**PLANNING APPROVAL,  
PLANNED UNIT DEVELOPMENT &  
SUBDIVISION STAFF REPORT****Date: July 10, 2008**

<b><u>NAME</u></b>	APUMC Subdivision
<b><u>SUBDIVISION NAME</u></b>	APUMC Subdivision
<b><u>LOCATION</u></b>	5, 7 and 15 Wisteria Avenue, 2315 Old Shell Road, 2312, and 2314 Dauphin Street (Southwest corner of Old Shell Road and Wisteria Avenue, extending to the North side of Dauphin Street, 160'± West of Wisteria Avenue, and 380'± West of Wisteria Avenue)
<b><u>CITY COUNCIL DISTRICT</u></b>	District 1
<b><u>PRESENT ZONING</u></b>	R-1, Single-Family Residential District
<b><u>AREA OF PROPERTY</u></b>	3 Lots / 4.6± Acres – Subdivision 1 Lot / 4.2± Acres – PUD and Planning Approval
<b><u>CONTEMPLATED USE</u></b>	Planning Approval to amend a previously approved Planning Approval to allow expanded parking and green space for an existing church in an R-1, Single-Family Residential District, Planned Unit Development Approval to amend a previously approved Planned Unit Development to allow the expansion of an existing church to include church office parking and expanded green space, and Subdivision approval to create three lots.

APPLICATION NUMBER 24,25,& 26 DATE July 10, 2008

REQUEST

# SITE PLAN

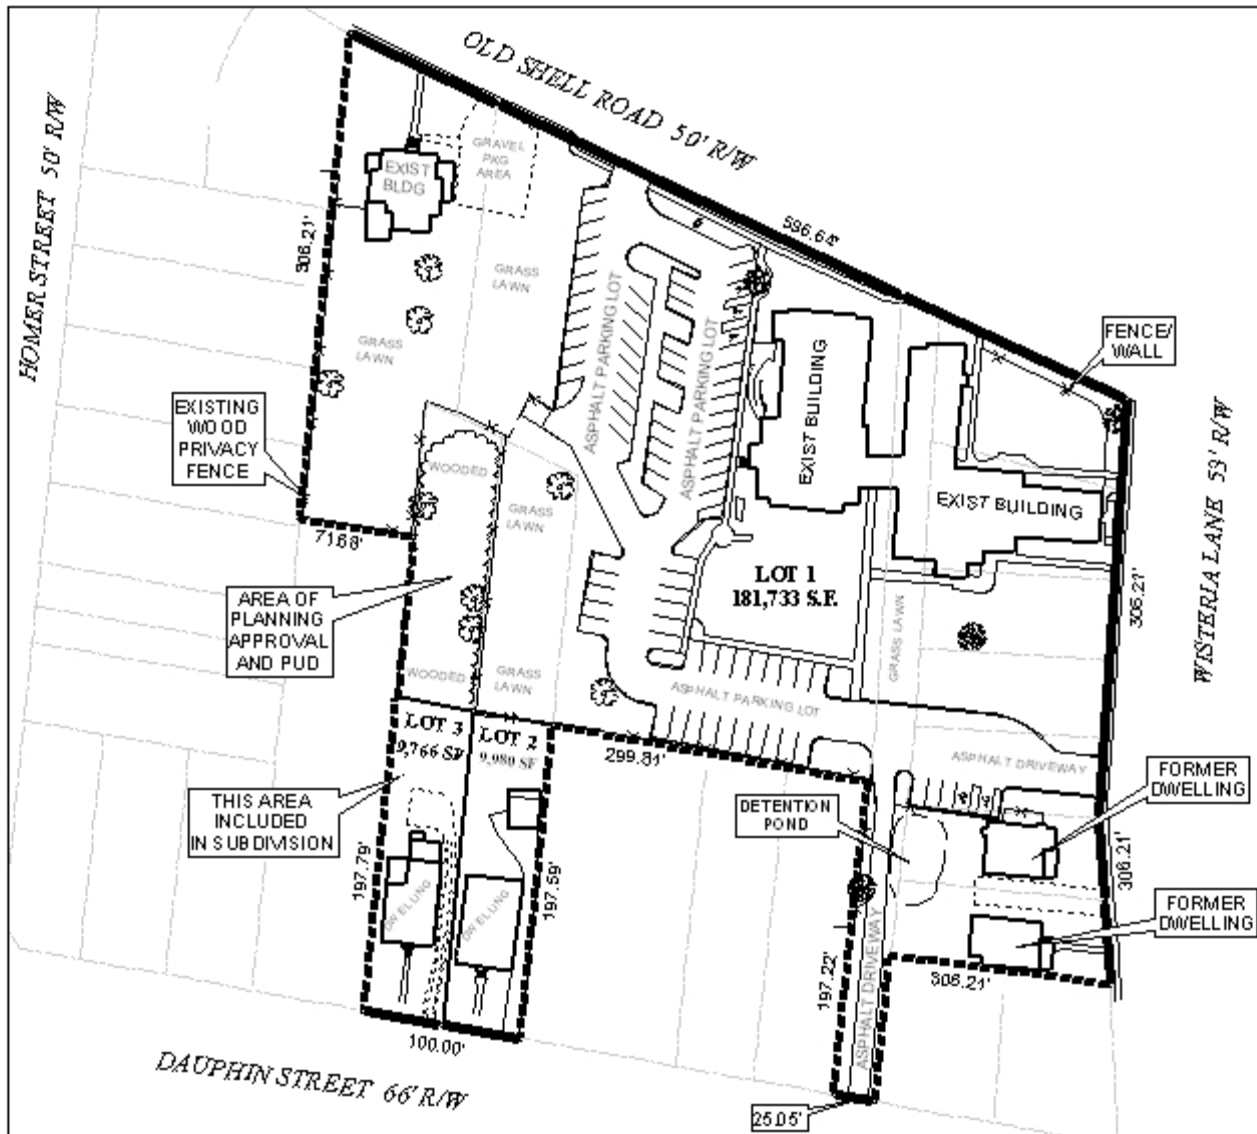
A six-foot high wooden privacy fence should be provided where the church abuts adjacent residential properties. A permit will be necessary to construct the fence where required.

The site plan indicates approximately 88 parking spaces, but no information is provided regarding the number of seats in the sanctuary nor calculations regarding existing tree and landscape information. As no facility expansion is proposed at this time, the lack of this information is not critical (especially due to previous approvals). However, future Planning Approval and PUD applications proposing expansion must provide detailed information.

Wisteria Avenue is mislabeled on the plat and site plan as Wisteria "Lane" – the plat and site plan should be revised with the correct name.

- 1) Limited to the site plan submitted, and the following revisions;
- 2) Provision, depiction and labeling of a 6-foot high wooden privacy fence where the site abuts residential uses, with appropriate permits;

- 3) Lot 1 is limited to one curb-cut to each road frontage (Old Shell Road, Wisteria Avenue, and Dauphin Street), with other curb-cuts to be removed and landscaped to match existing (with appropriate permits);

- 6) Depiction and labeling of the 25-foot minimum building setback line along the Old Shell Road and Wisteria Avenue frontages, and depiction of the setback line as 75-feet from the centerline along the Dauphin Street frontage;

- 7) Revision of the site plan to depict correct street names;
- 8) Provision of a revised Planning Approval site plan to the Planning Section of Urban Development prior to the signing of the Subdivision plat;
- 9) Completion of the Subdivision process prior to any future applications to the Planning Commission; and
- 10) Full compliance with all other municipal codes and ordinances.
